MEMORANDUM

From:	Tina Cuss Ecology Officer		
Service	WBC Ecology	App No:	242960
Address:	Heriots, Wokingham Road, Hurst, Wokingham, RG10 0RX.		
Proposal:	Householder application for the proposed erection of a single storey extension; link extension to curtilage listed outbuilding and enlargement of first floor element over kitchen (part-retrospective). Removal of flue on east elevation; removal of black timber cladding from west gable end and two storey element of east elevation; replacement of ground floor French doors on east elevation with triple windows; alteration and extension of first floor rear extension.		
Type of Development:	Other Householder		
Site Visit Made:	No

Figure 4. Southern elevations (western half) looking north. Red arrows indicate potential openings for crevice roosting bats.

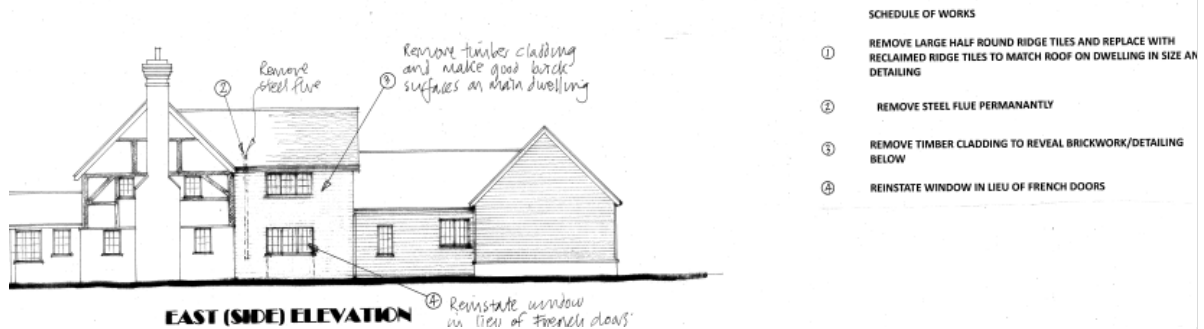
The external survey undertaken by the Ecologist recorded numerous openings into the under-tile spaces on the roof and into the under eaves which could provide access to bats as well as a potential opening at the apex of the north gable of the northern extension. The Ecologist does not specify what the constraint to completing the survey were, but it appears roof space above the northern extension was inaccessible, an internal inspection were limited to just the main oldest building. The Ecologist observed a number of old bat droppings on the floor of the main loft of the oldest. The Phase 1 Bat Assessment does not include DNA analysis of the bat dropping or describe their size and shape and suggest whether they are consider what species of bat is likely to have deposited them. The report does not include a plan of the potential roosting features and gaps which could provide access to roof voids or roosts for crevice-dwelling bats. The Daytime Bat Assessment has not assessed the detail of the works which are proposed. In particular the works ① detailed on the Proposed Elevations Dwg 2432/04 Rev C to remove large half round ridge tiles and the removal of timber cladding.

I am concerned that the Ecologist's summary includes serious errors that therefore there are both no signs of bat activity and low potential for bats, and that the assessment has not been carried out in full accordance with Bat Surveys for Professional Ecologists: Good Practice Guidelines 4th edition. I do agree that, because there is evidence of roosting bats within the loft of the house and roof voids in the north wing and above the single storey extension were inaccessible to the ecologist, and because the clay tiles and ridge tiles have dozens of potential openings for crevice-dwelling bats, that the property has high bat roosting potential. I disagree that a single emergence survey is adequate or in line with the Good Practice Guidelines.

Unless a report is submitted providing the results and assessment of at least three separate dusk emergence surveys completed at least three weeks apart during the bat active season (i.e. between May and the end of August/ sub optimally until September) the planning application must not be approved. The report should compensation proposals which can be secured and detailed mitigation strategy that is prepared in line with current UK Bat Mitigation Guidelines best practice.
